SUBJECT: WOLF CREEK GENERATING STATION - AMENDMENT NO. 32 TO FACILITY  
OPERATING LICENSE NO. NPF-42 (TAC NO. 72993)

Amendment No. 32  
License No. NPF-42

ATTACHMENT TO LICENSE AMENDMENT NO. 32

SAFETY EVALUATION BY THE OFFICE OF NUCLEAR REACTOR REGULATION  
RELATED TO AMENDMENT NO. 32 TO FACILITY OPERATING LICENSE NO. NPF-42

FIGURE 3.1-1

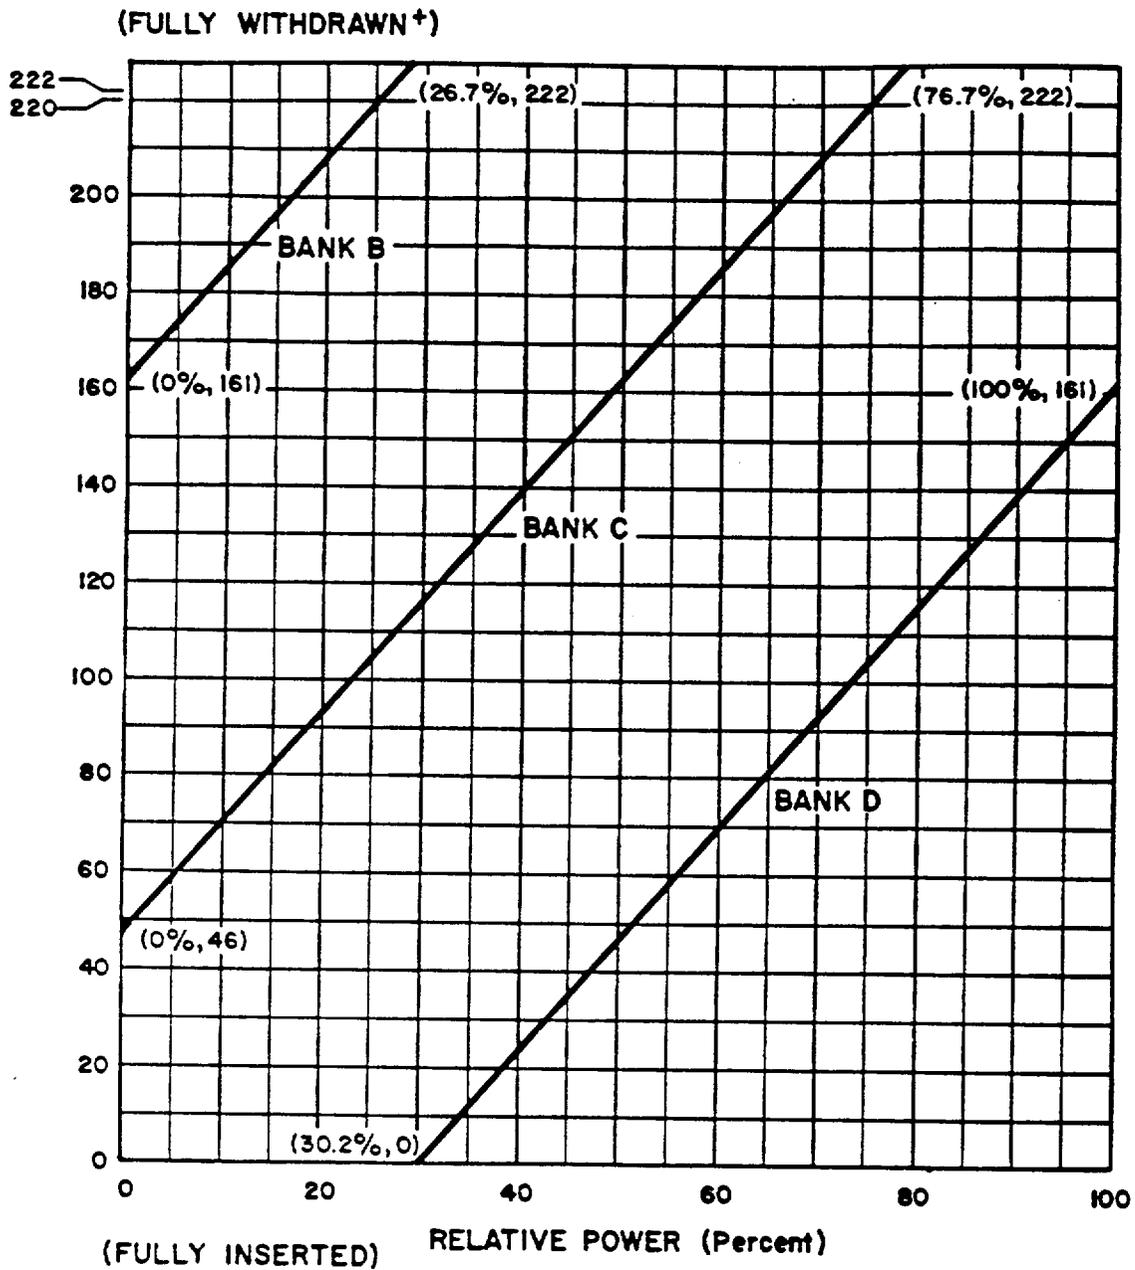
The amendment revises Technical Specifications 3.1.3.4 and Figure 3.1-1 to change the fully withdrawn position of the Rod Cluster Control Assemblies to a range of 222 to 231 steps, inclusive.

By letter dated April 13, 1989 the licensee proposed to revise Technical Specifications 3.1.3.4 and Figure 3.1-1 to change the fully withdrawn position of the Rod Cluster Control Assemblies (RCCAs) for Wolf Creek Generating Station to a range of 222 to 231 steps, inclusive.

The licensee proposed the change to minimize localized RCCA wear at the top of the control rods. The proposed technical specification change will allow operation with the RCCAs positioned between 222 steps and 231 steps withdrawn as compared to the current fixed position of 228 steps. With the RCCAs positioned at 222 steps withdrawn, the tips of the RCCAs will be approximately 3 steps (1.875 inches) into the active fuel region. Since the top region of the core has such low worth, the resultant power distribution perturbations are expected to be negligible and should be accommodated with available margin. As expected, calculations by the licensee show that operation with the rods positioned at 222 steps withdrawn will have minimal impact on axial peak power and axial offset over the life of the fuel cycle.

<sup>†</sup>Fully Withdrawn shall be the condition where control rods are at a position within the interval of  $\geq 222$  and  $\leq 231$  steps withdrawn.
